Access Compliance Report

Public Rights-of-Way

(Curb Ramps)

Intersection ID: 30078	Main Street: SUNSET_RD	Cross Street: WOODLANDS_POINTE_DR	Location: NW
ADA ID: 463F3324204E	Ramp Type: Perp	Initial Pass/Fail: Fail	Overall Compliance: No
Severity Score: 1.25			
Codes/Mitigation Info/Possible Solution		Field Measurements/Component Compliance

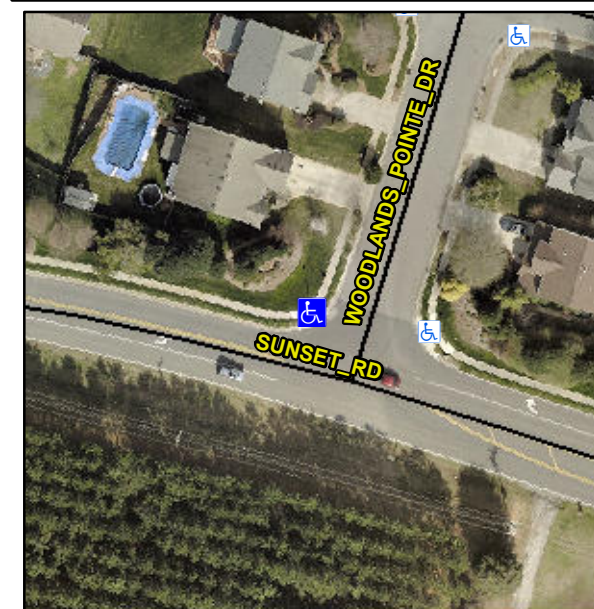
R304.5.3

Compliance	Description	Data	Compliance	Description	Data
N/A	Ramp Length (in)	74.0	Yes	Ramp Slope (%)	8.3
Yes	Ramp Width (in)	48.0	No	Ramp XSlope (%)	2.9
N/A	Flare Type LT	N/A	N/A	Flare Type RT	N/A
N/A	Flare Slope LT (%)	N/A	N/A	Flare Slope RT (%)	N/A
N/A	Flare Traversable LT?	N/A	N/A	Flare Traversable RT?	N/A
N/A	Landing Length (in)	N/A	N/A	DWS Provided?	N/A
N/A	Landing Width (in)	N/A	N/A	DWS Contrast?	N/A
N/A	Landing Slope (%)	N/A	N/A	DWS Length (in)	N/A
N/A	Landing X Slope (%)	N/A	N/A	DWS Full Width?	N/A
N/A	Landing Curb? (Y/N)	N/A	N/A	DWS Offset (in)	N/A
N/A	Shared Landing?	N/A			
N/A	Gutter Ponding?	N/A	N/A	Gutter Slope (%)	N/A
N/A	Gutter Lip Ht (in)	N/A	N/A	Gutter X Slope (%)	N/A
N/A	Painted X Walk1?	No	N/A	Painted X Walk2?	N/A
	X Walk 1 Direction	To SE		X Walk 2 Direction	N/A
N/A	X Walk 1 Width (in)	N/A	N/A	X Walk 2 Width (in)	N/A
	X Walk 1 Slope (%)	3.1		X Walk 2 Slope (%)	N/A
	X Walk 1 X Slope (%)	5.7		X Walk 2 X Slope (%)	N/A

Remove & Replace Entire Ramp.
